Northgate Pedestrian Bridge

**Department of Planning
and Development**
700 5th Avenue, Suite 2000
PO Box 34019
Seattle, WA 98124-4019

Meeting Summary

This was the Seattle Design Commission's (SDC) second review of the Northgate Pedestrian Bridge project. At the commission's August 7, 2014 meeting, the SDC unanimously approved the applicant's pre design study. Today, the commission reviewed the concept design phase of the project. Following the presentation, public comment and SDC review, the SDC voted 7-0 in favor of the concept design, with recommendations.

Figure 3. Previous (left) and proposed (right) ramp realignment along eastern approach

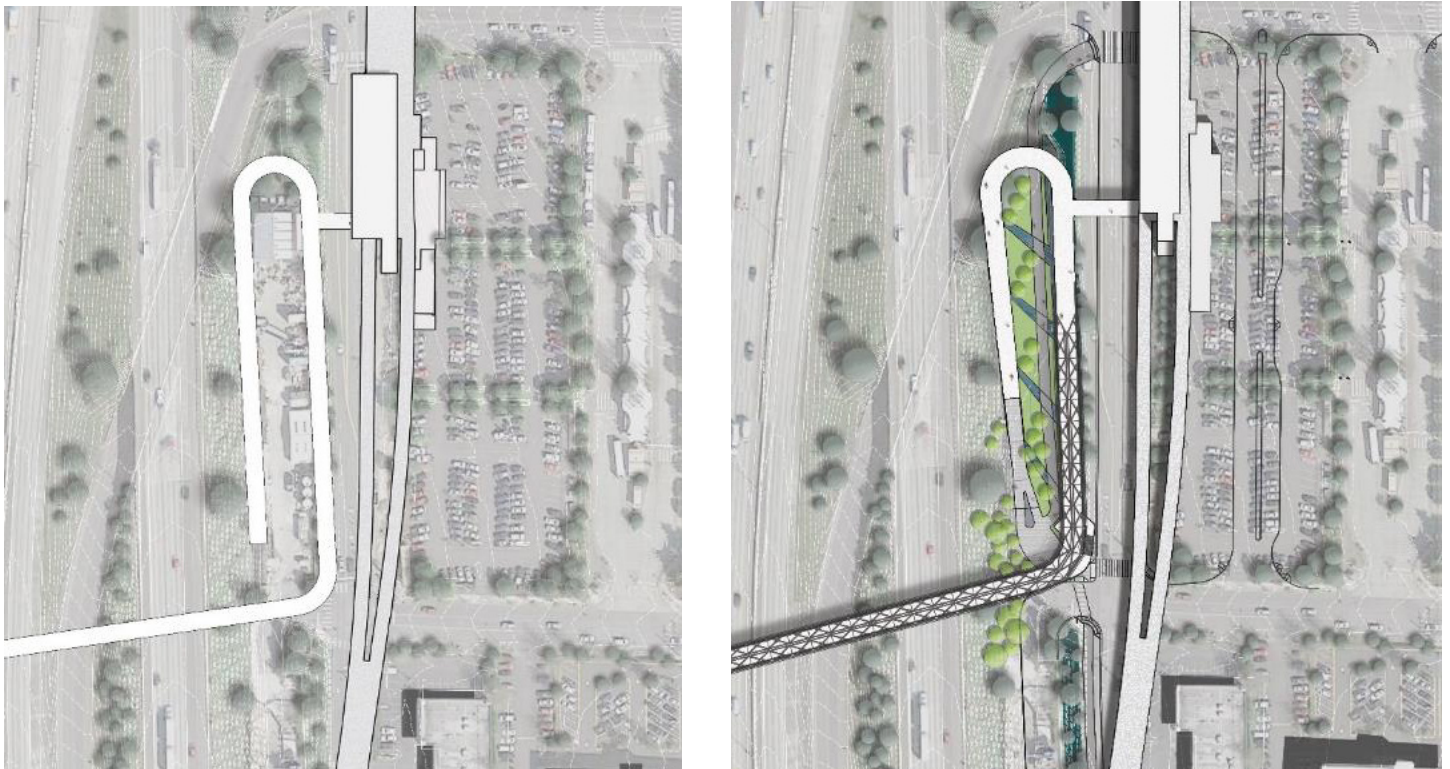
The commission appreciated the design team's resolution of the bridge alignment. Although the alignment had improved from the previous design, the commission was concerned with equitable access among users. The design team proposed ADA accessible ramps at a 4.8% slope and a bridge spur connecting to the light rail station at the east. Commissioners discussed the merits of providing elevators at each approach to provide the shortest possible

route for those needing ADA access. Under the current proposal, using the ramps for ADA access would result in the farthest route to travel for those who need such access. The commission has encouraged the design team to place more thought into designing a shorter, more accessible route from North Seattle College to the light rail station.

1. Work with North Seattle College to resolve pedestrian and bicycle access from the bridge to the college
2. Resolve whether it is feasible to include an elevator on the western approach next to the proposed staircase
3. Engage with the project artist during the remaining design process
4. Explore creating a neighborhood gateway along the east terminus of the bridge where the staircase and ramp path intersect
5. Gradually transition from the concrete girder to steel tube and truss system in order to create a visually cohesive design
6. Continue exploring the design of the lighting system as it transitions from the railing into the landscape on both the east and west side of bridge.

Figure 4. Proposed access points

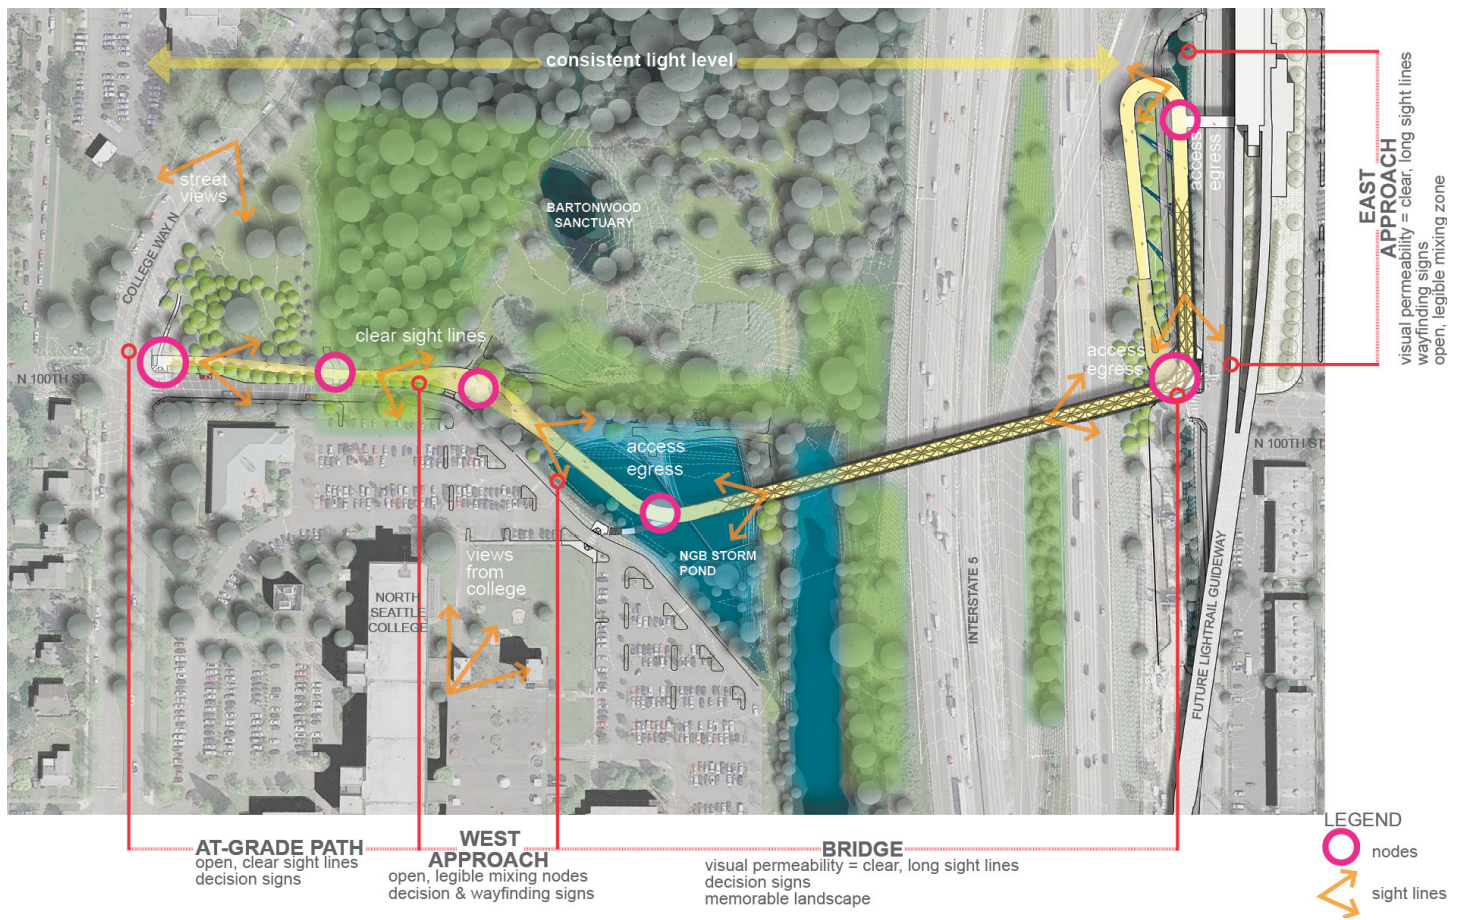
Robin Randels, from Cascade Bicycle Club, expressed interest in making sure bicycles coming down the ramp are separated from pedestrians. Ms. Randels appreciates having stairway connections and would like to have 24 hours access to the light rail station's mezzanine level entrance.

Figure 6. Rendering of structural tube

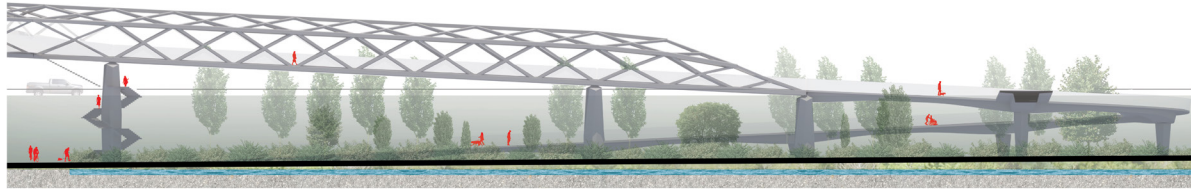
Overall, the commission was very enthusiastic about the concept design for the bridge. While the Commissioners commended the design team for integration of the various materials and the transition points from tube to uncovered bridge deck, they also expressed concern about how the transition between design elements would occur. Commissioners highlighted the importance of blending the various materials, forms, and elements into a cohesive design to achieve the intended results. Transitions, from bridge deck to the steel superstructure, as well as between bridge segments and individual parts, would be of great importance. The commission encouraged the design team to consider the role of the bridge as a gateway to the Northgate and Maple Leaf neighborhoods as they further designed the eastern terminus.
